BID ADDENDUM

PROJECT NUMBER	PROJECT TITLE		
23-02258	Queens Elevators – Watson Hall		
PROJECT LOCATION / ADDRESS		DATE ISSUED	ADDENDUM #
Watson Hall, 49 Bader Lane, Kingston ON		April 29, 2026	04

Architectural Addendum No. 4

Queen's Elevator Project – John Watson Hall Kingston, Ontario

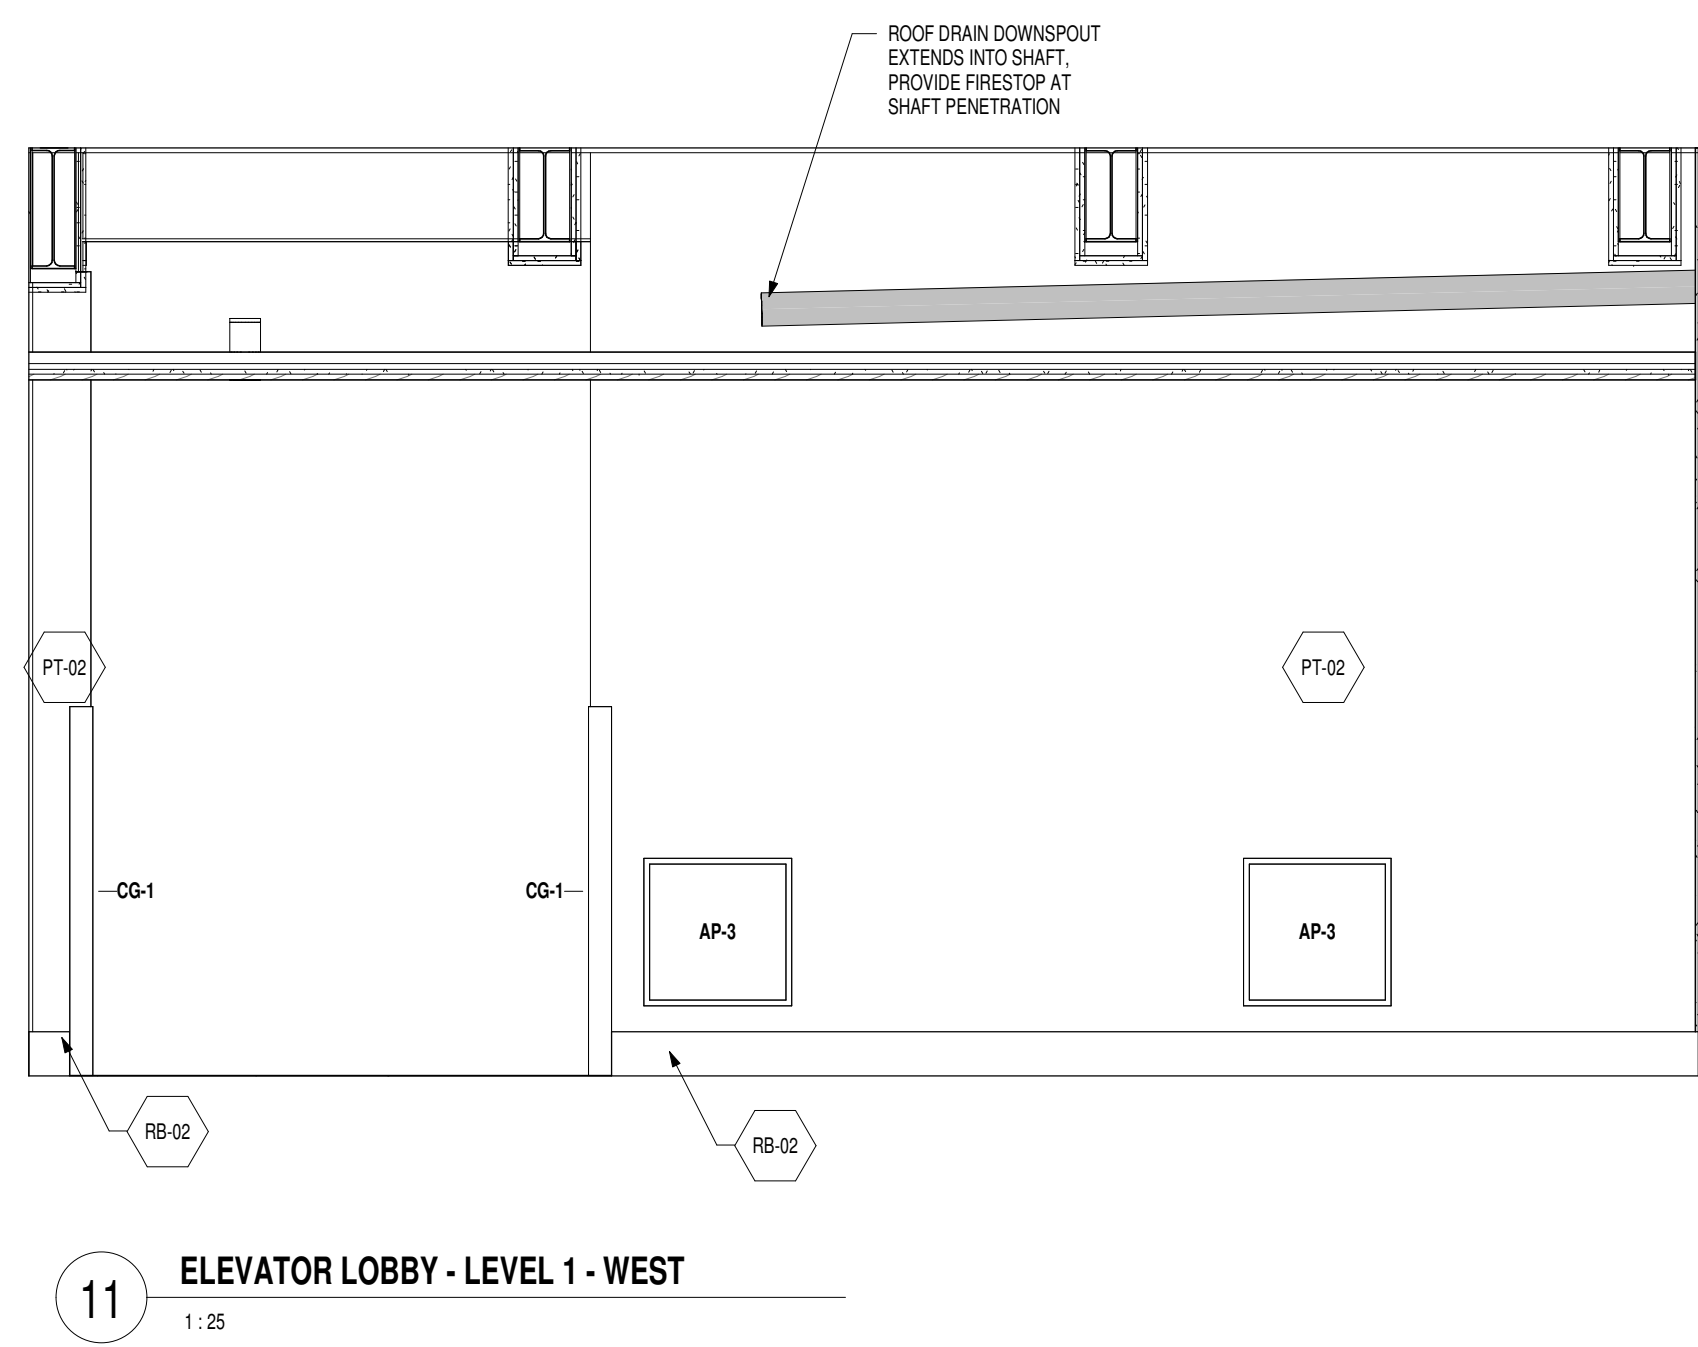
Please note 2.3.6 Above states to look at A7.40. A7.40 is the table Below.

A7.40 reads that Rb-01 should be painted to match existing in basement and Rb-02 is to receive wood stain to match existing on upper floors.

Please let me know if it is to be rubber

Answer: Basis of design products and finishes are added to RB-01 and Rb-02 notes. Refer to attached A7.40.
